| Charlotte Historic District Commission |
| Staff Review |
| HDC 2016-191 |

| PROPERTY ADDRESS: | 1948 Park Road |

| L 3 1/2" x 3 1/2" x 1/4" | Not More Than 3'-6" | 4" Bearing |

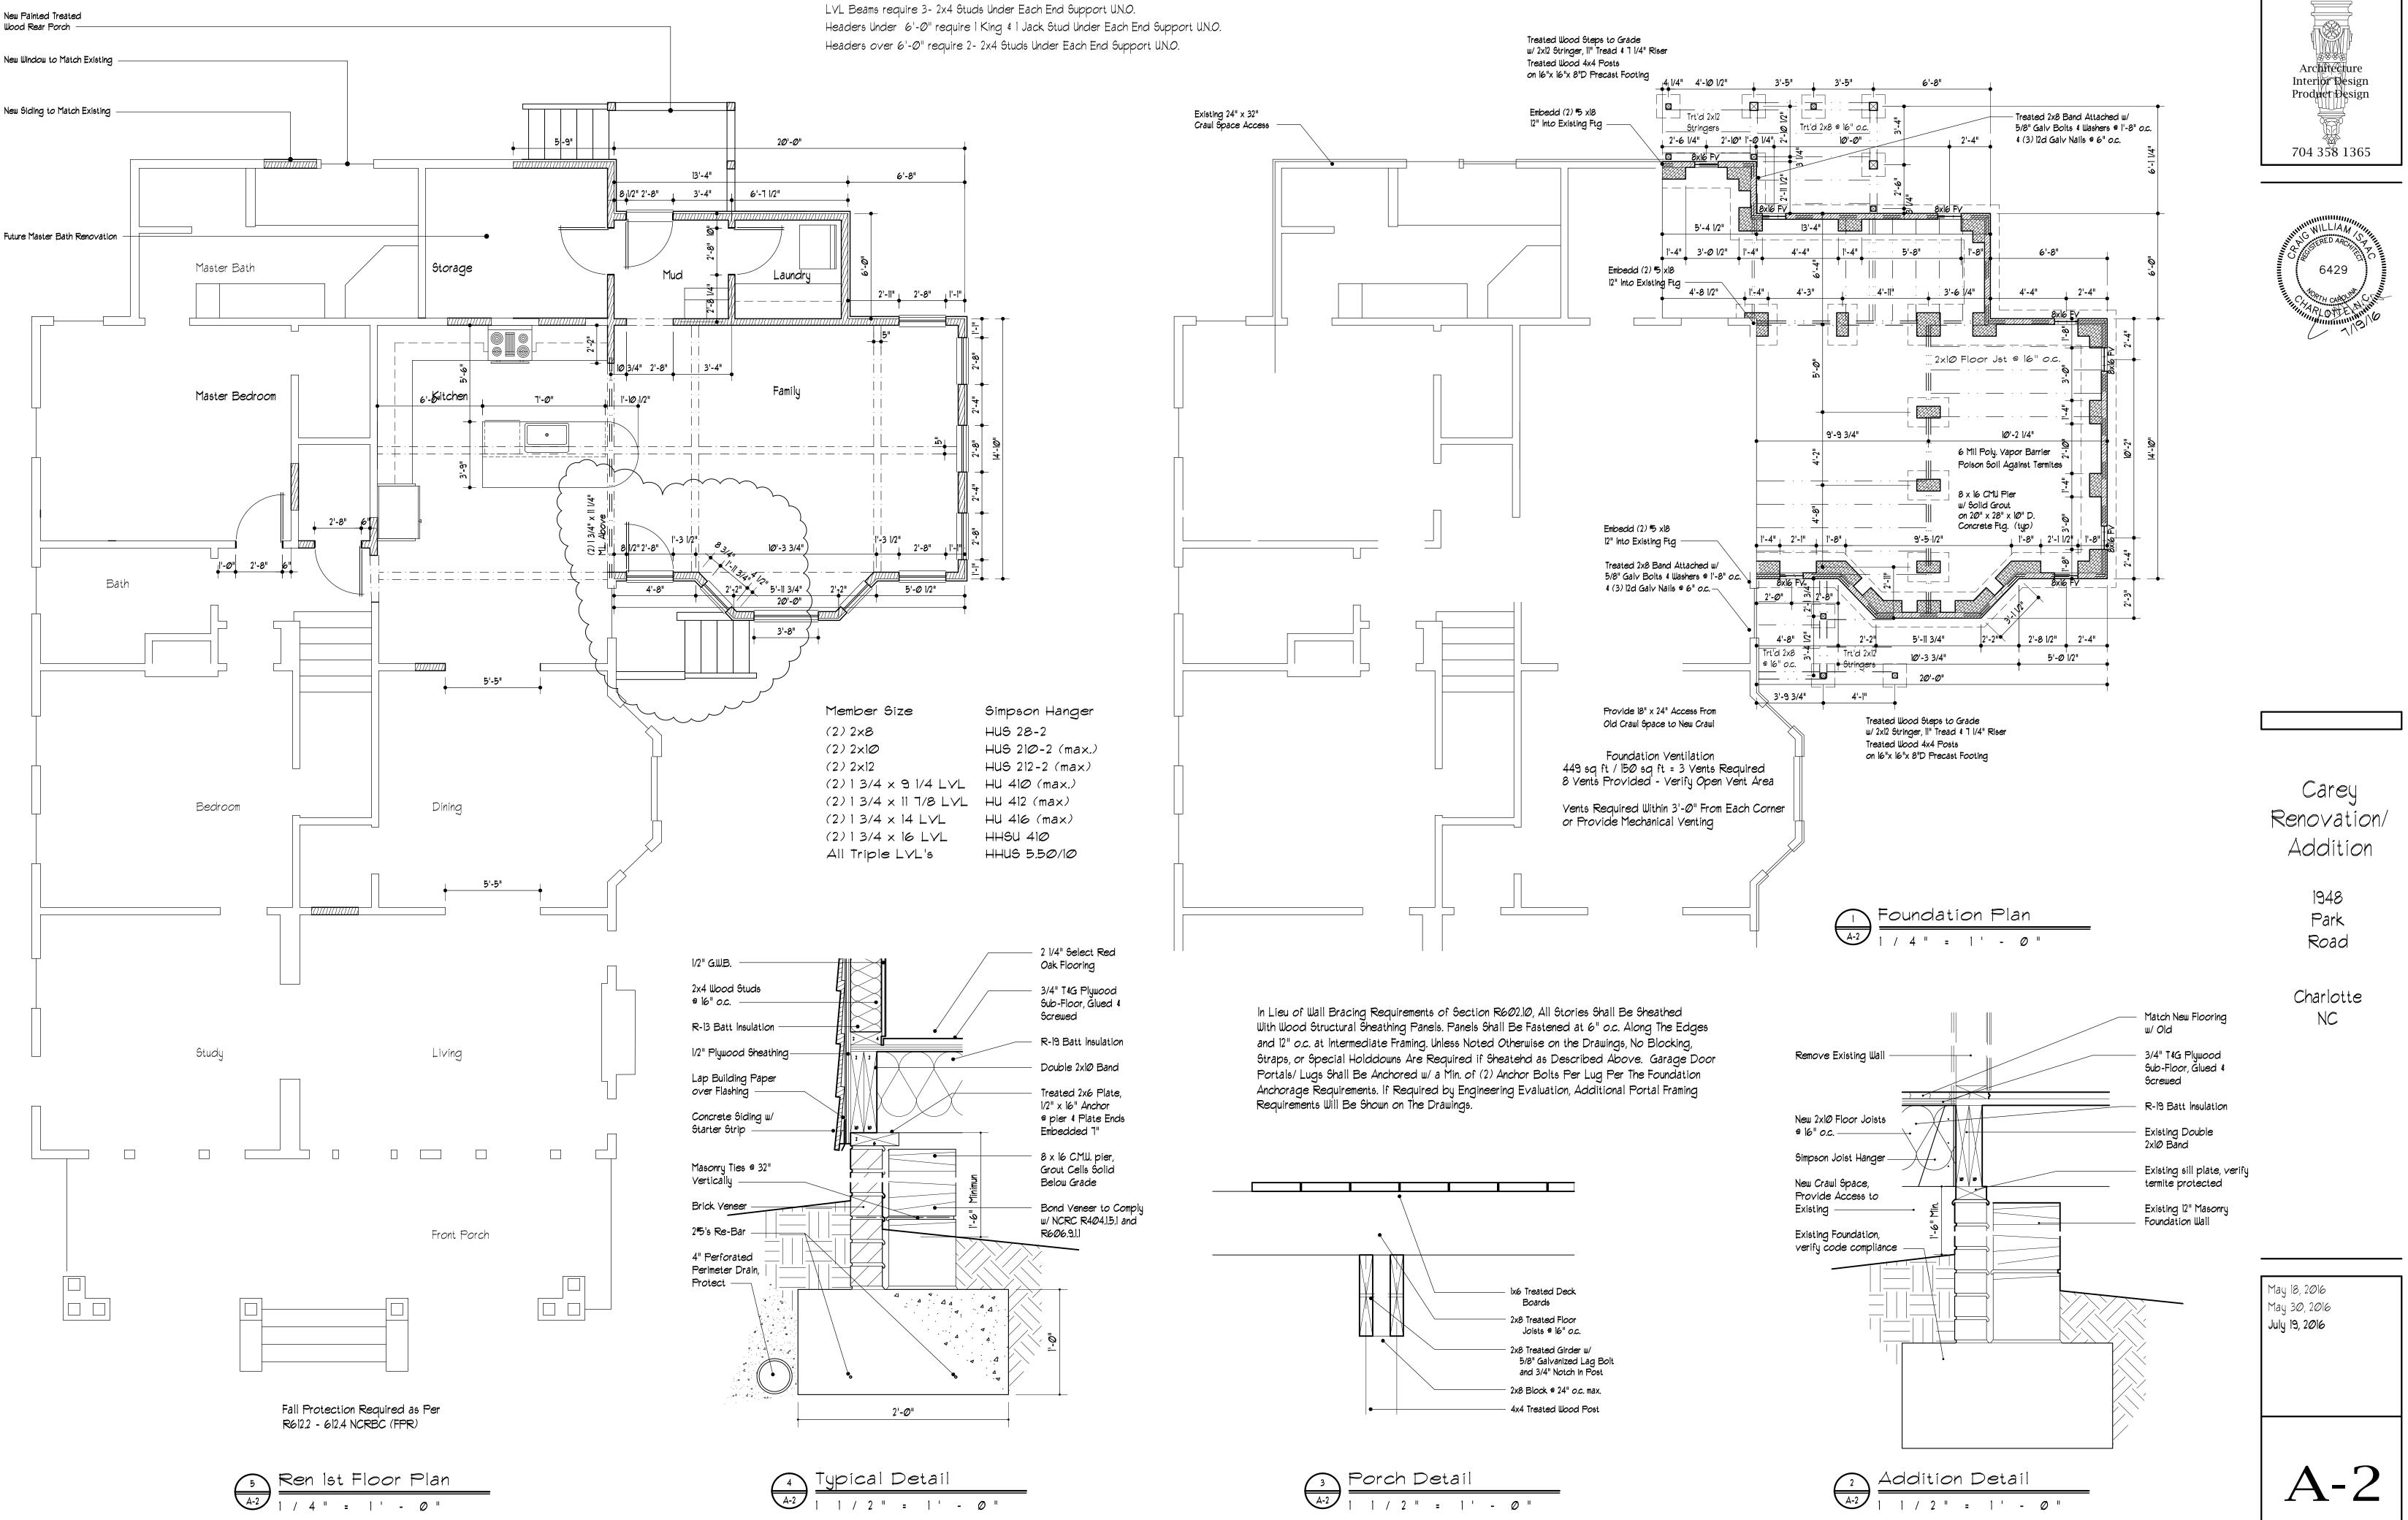
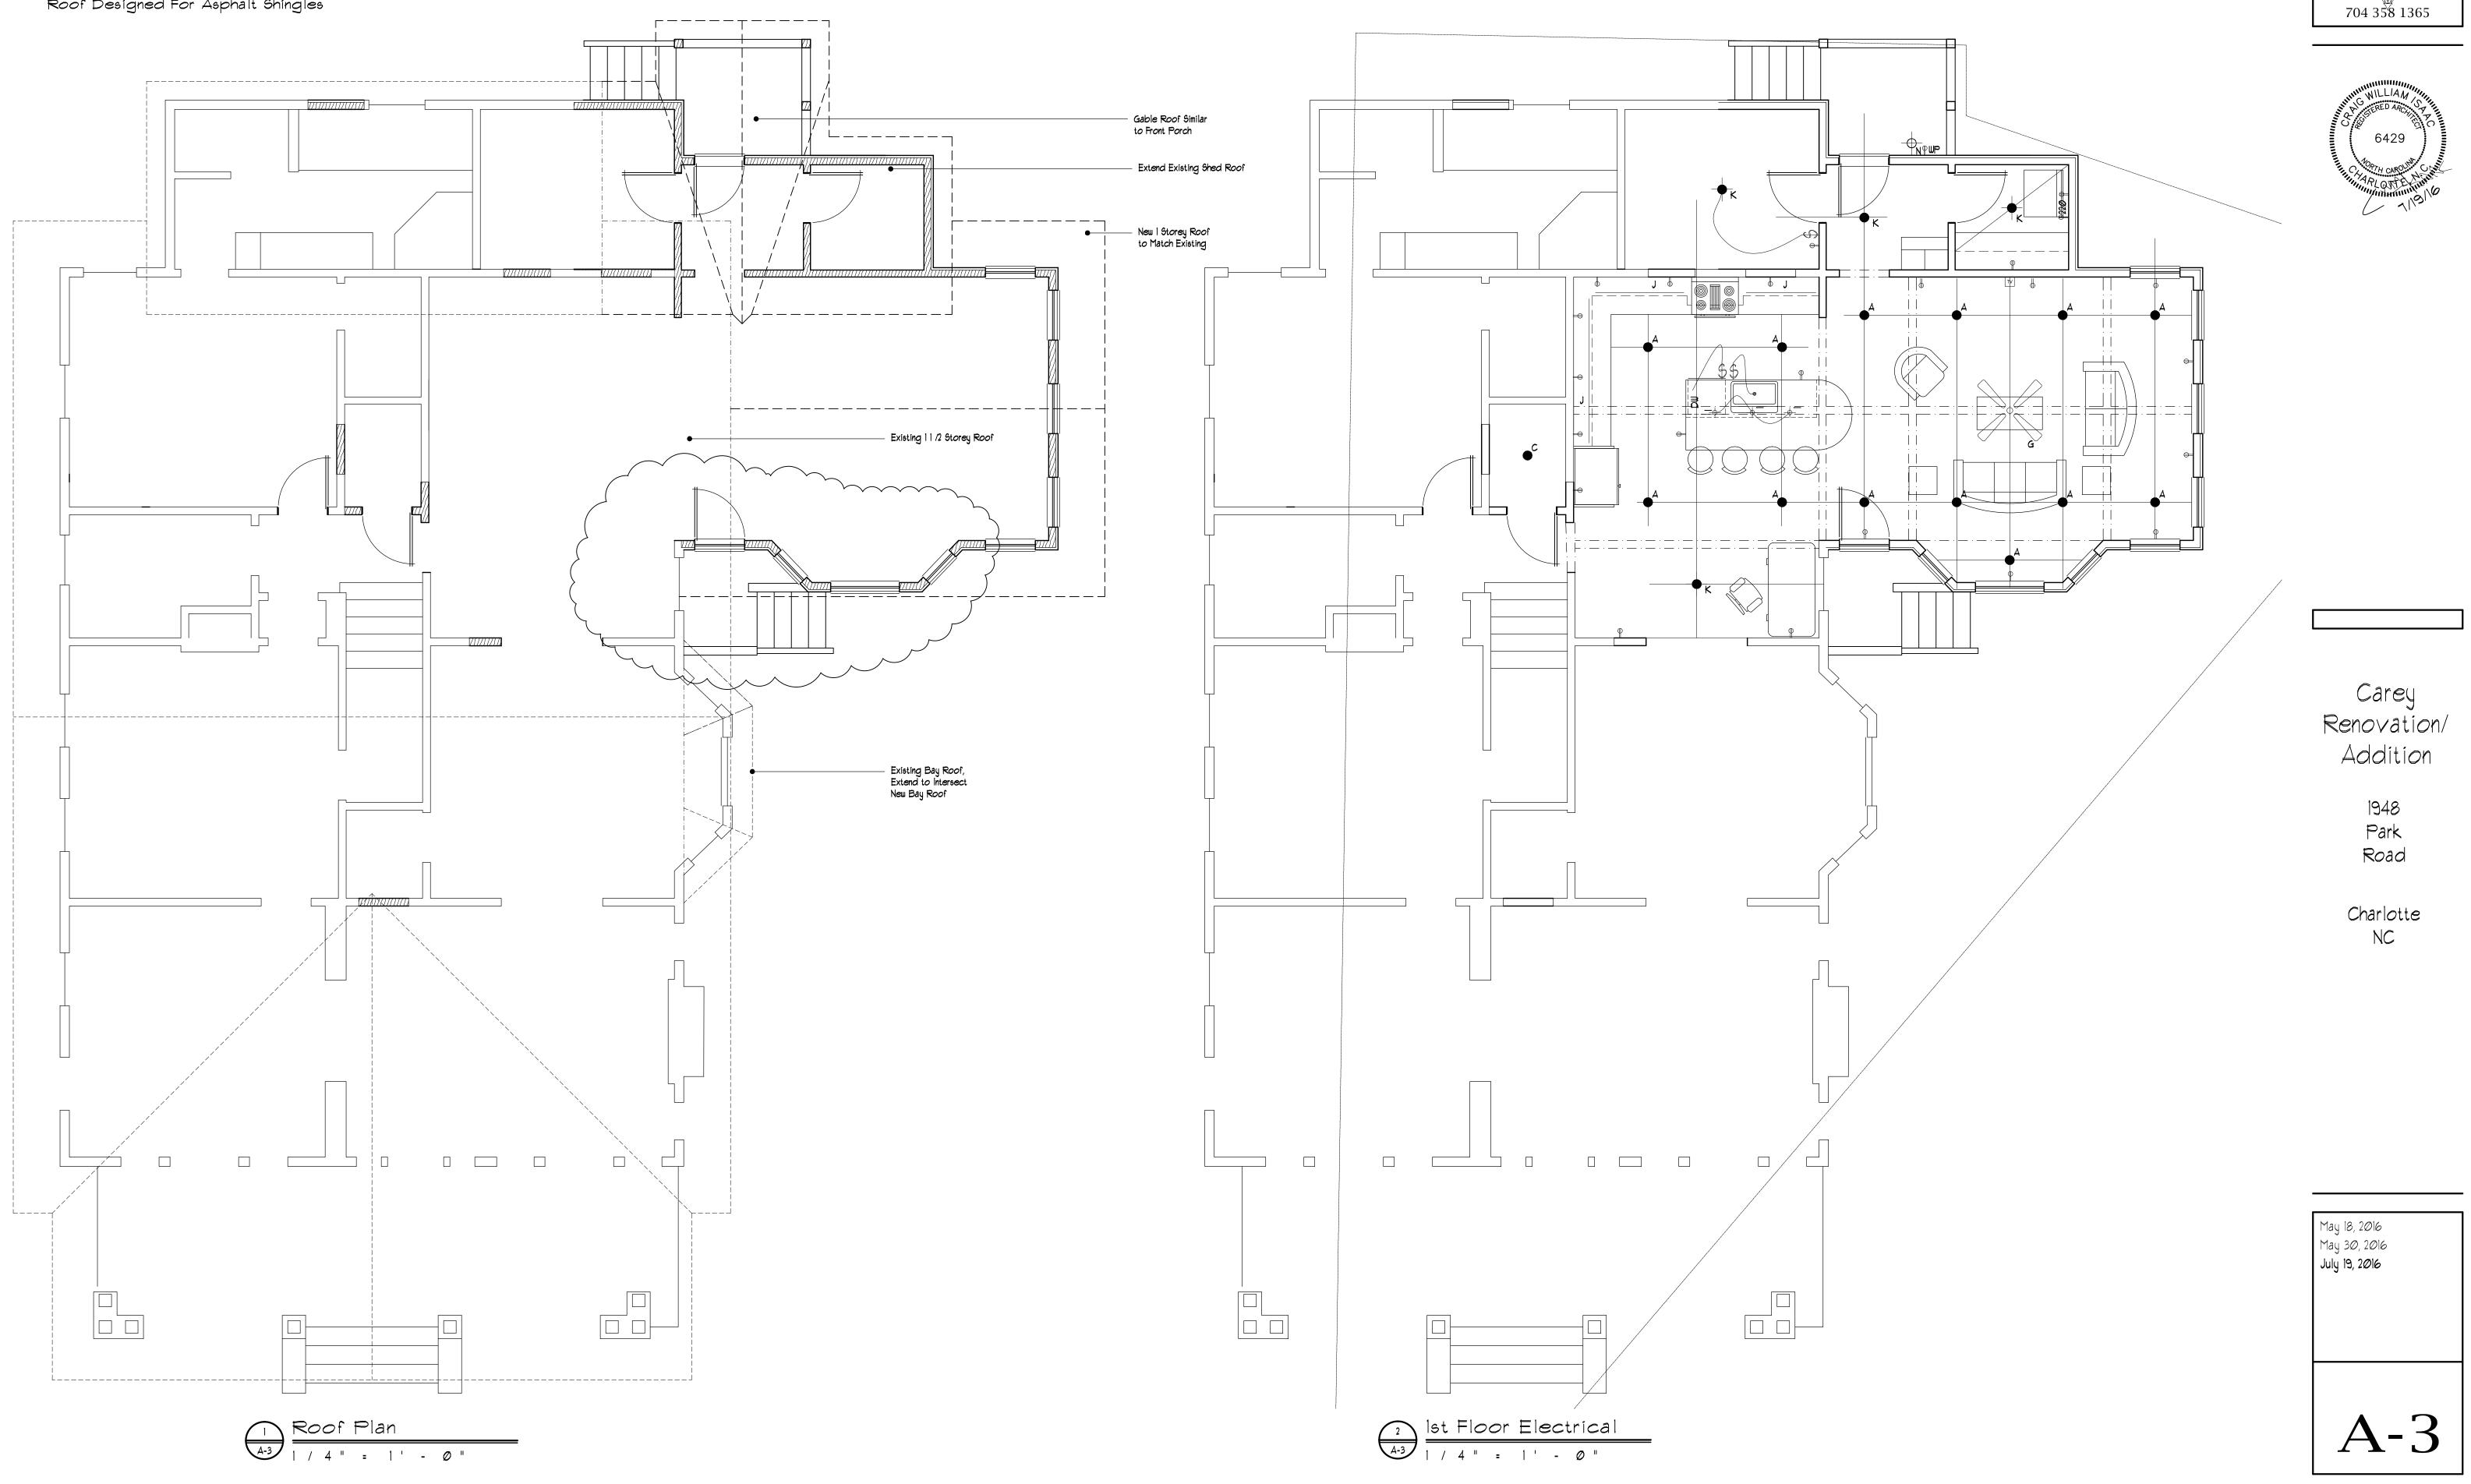
A small one story addition was approved by the HDC June 8, 2016. Details of the motion - *Disconnect the roofline at the side back door, and the stairway, it is going to be a window instead of a door and screen.*

The applicant is applying for a revision to the side addition which includes a simplified roof connection and a stair and door from the interior living space. New materials, windows and trim will match existing. The rear porch addition was approved.

<u>Staff Analysis</u> The Commission will determine if the proposal meets the guidelines for additions.
